COMMISSION ON COMMUNITY INVESTMENT AND INFRASTRUCTURE

RESOLUTION NO. 20-2023

CONDITIONALLY APPROVING THE SCHEMATIC DESIGN FOR UNDER RAMP PARK; ADOPTING ENVIRONMENTAL FINDINGS PURSUANT TO THE CALIFORNIA ENVIRONMENTAL QUALITY ACT; AND PROVIDING NOTICE THAT THIS ACTION IS WITHIN THE SCOPE OF THE TRANSBAY TERMINAL/ CALTRAIN DOWNTOWN EXTENSION/ REDEVELOPMENT PROJECT FINAL ENVIRONMENTAL IMPACT STATEMENT/ ENVIRONMENTAL IMPACT REPORT (“FEIS/EIR”), A PROGRAM EIR, AND IS ADEQUATELY DESCRIBED IN THE FEIS/EIR FOR PURPOSES OF THE CALIFORNIA ENVIRONMENTAL QUALITY ACT; TRANSBAY REDEVELOPMENT PROJECT AREA

CONDITIONS OF APPROVAL FOR THE TRANSBAY UNDER RAMP PARK SCHEMATIC DESIGN

PHASING

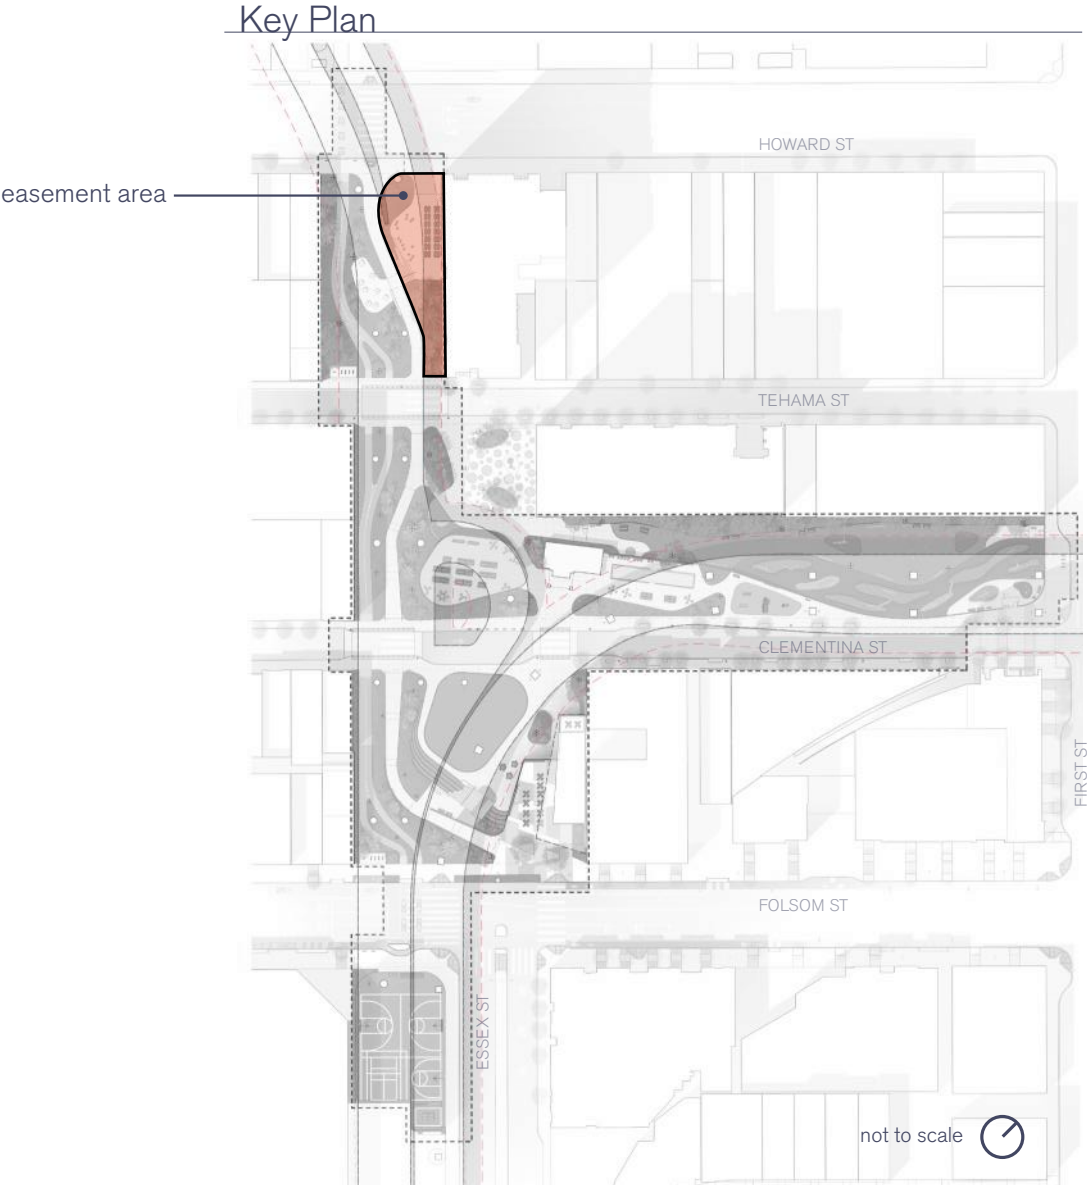
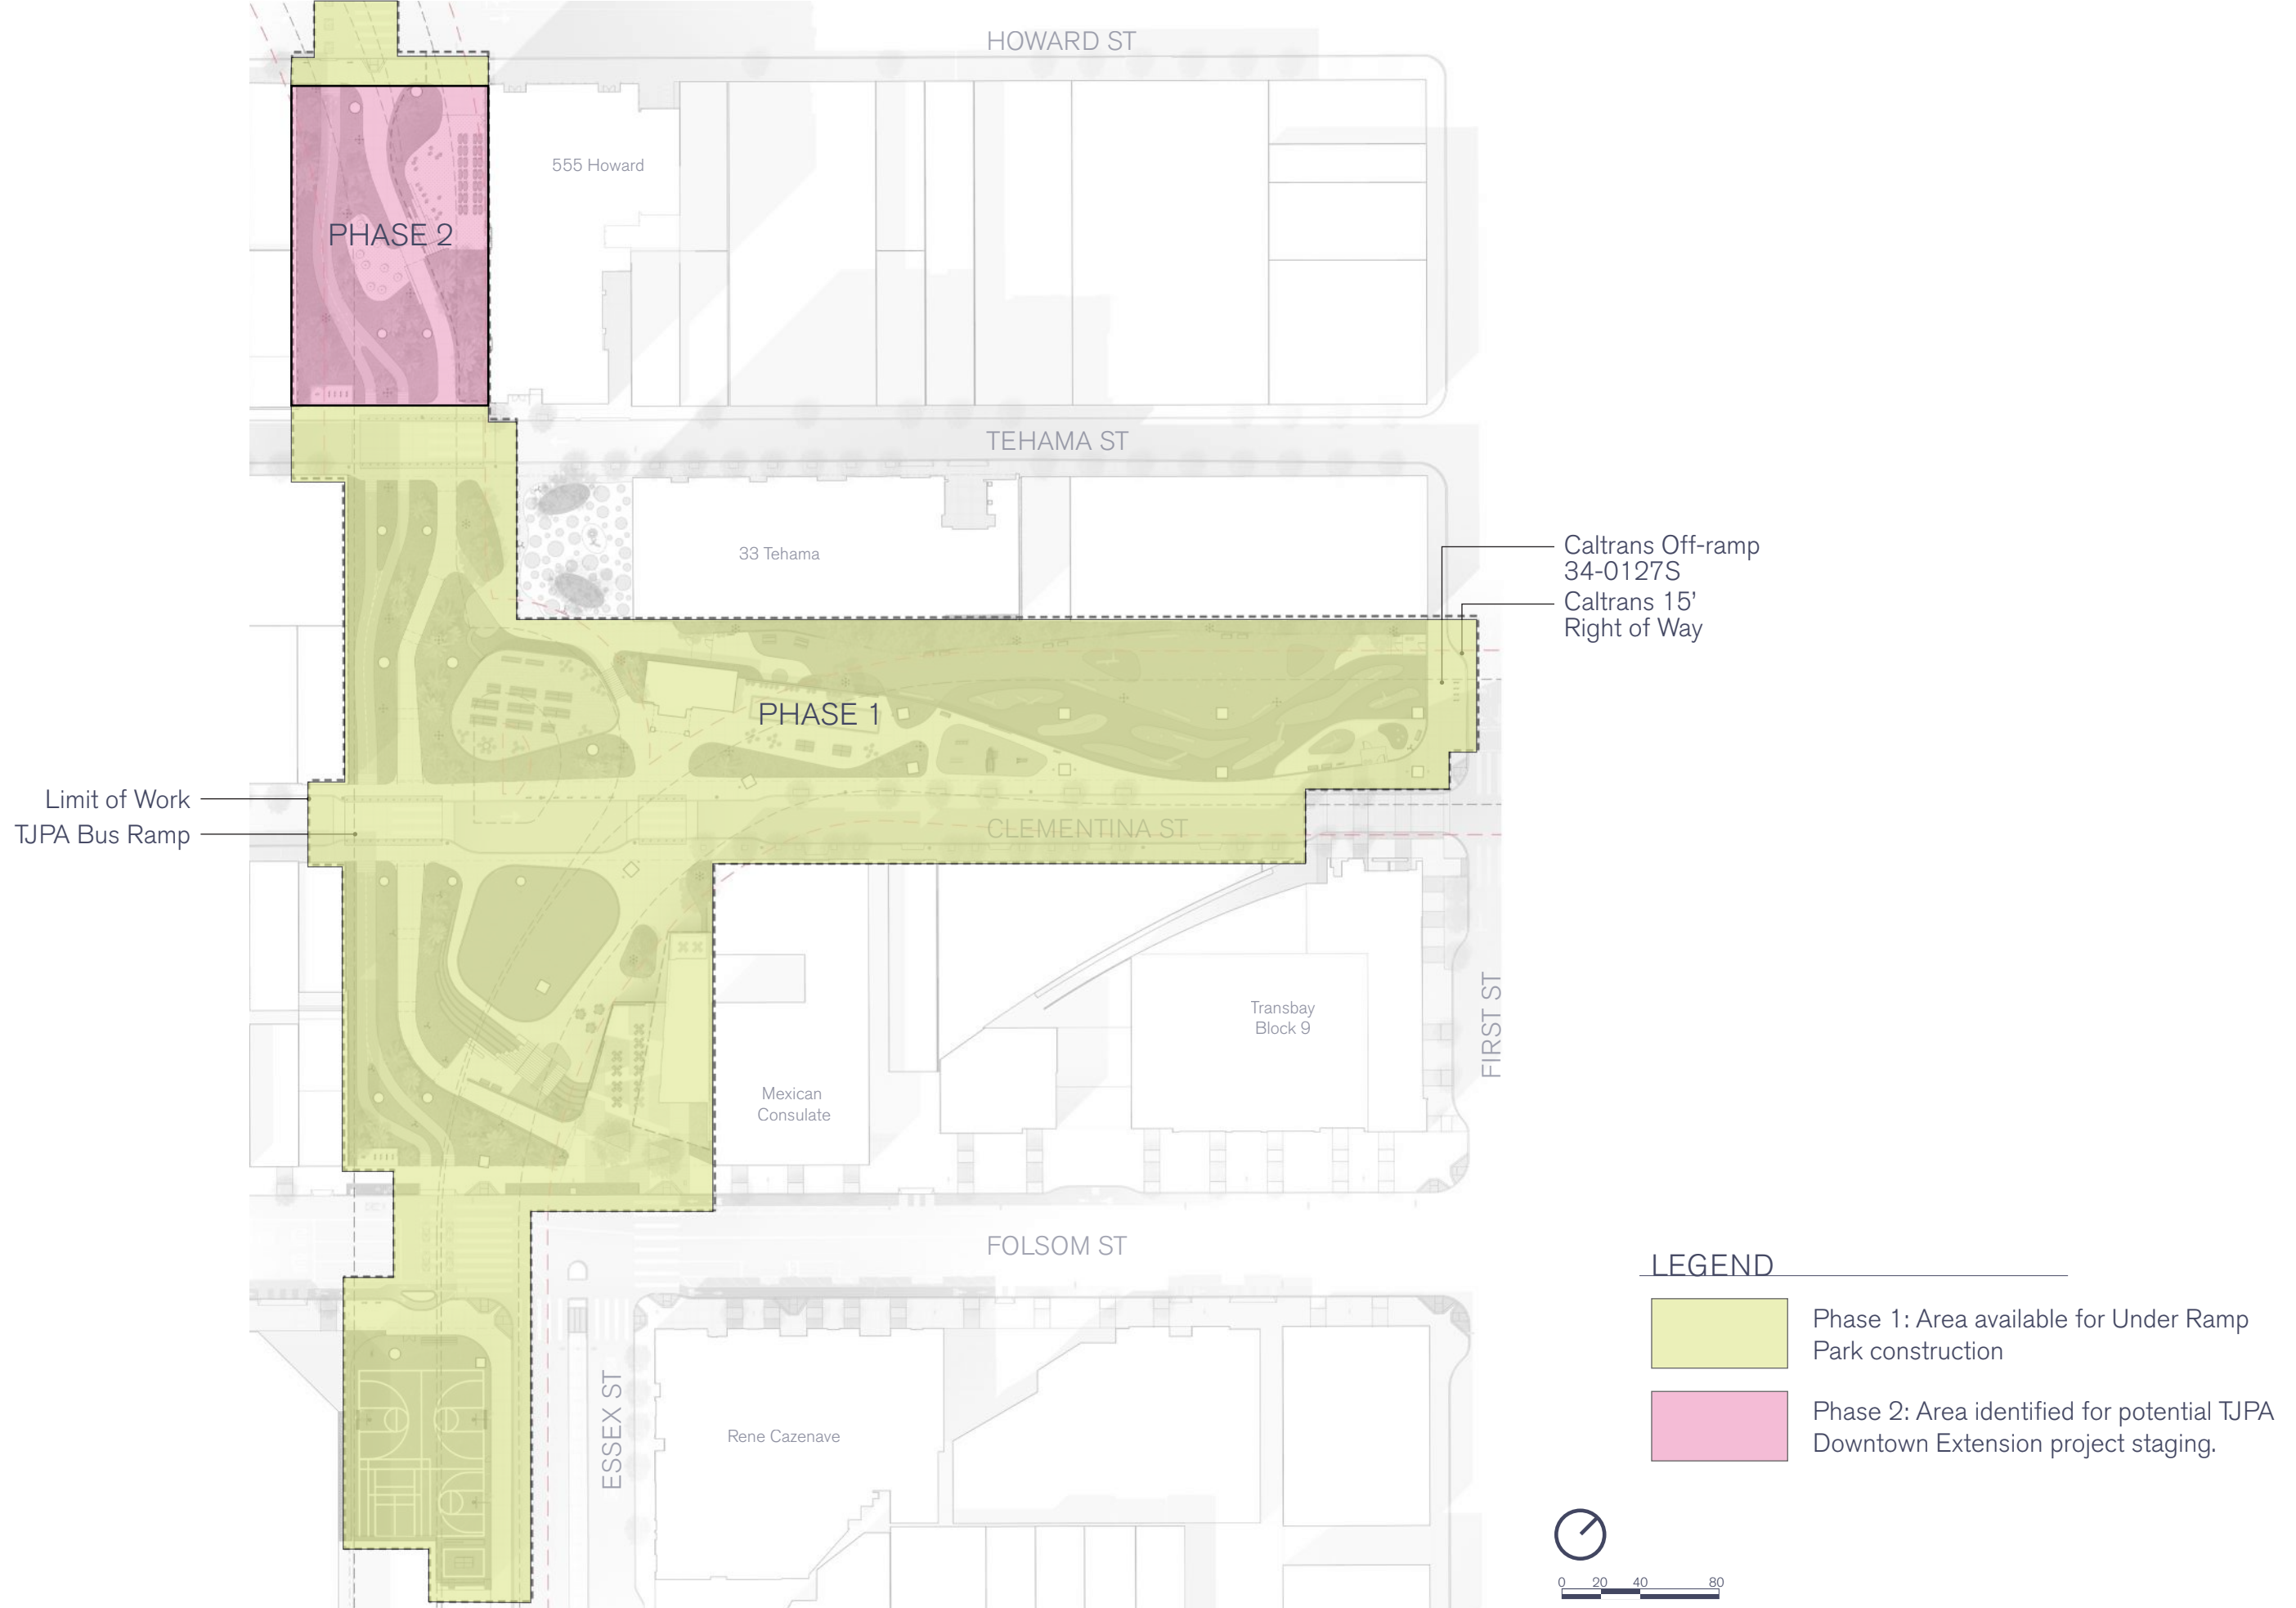
10. **Phasing Plan:** Further refine the phasing plan, in coordination with TJPA and OCII staff, to incorporate TJPA's future needs for providing staging area for the Downtown Rail Extension ("DTX") project. If applicable, provide an interim plan showing elements of the two-way bicycle and pedestrian pathway as well as the easement of the future 555 Howard development, that shows the design of the Phase 2 block until the final buildout is approved for construction by the TJPA.
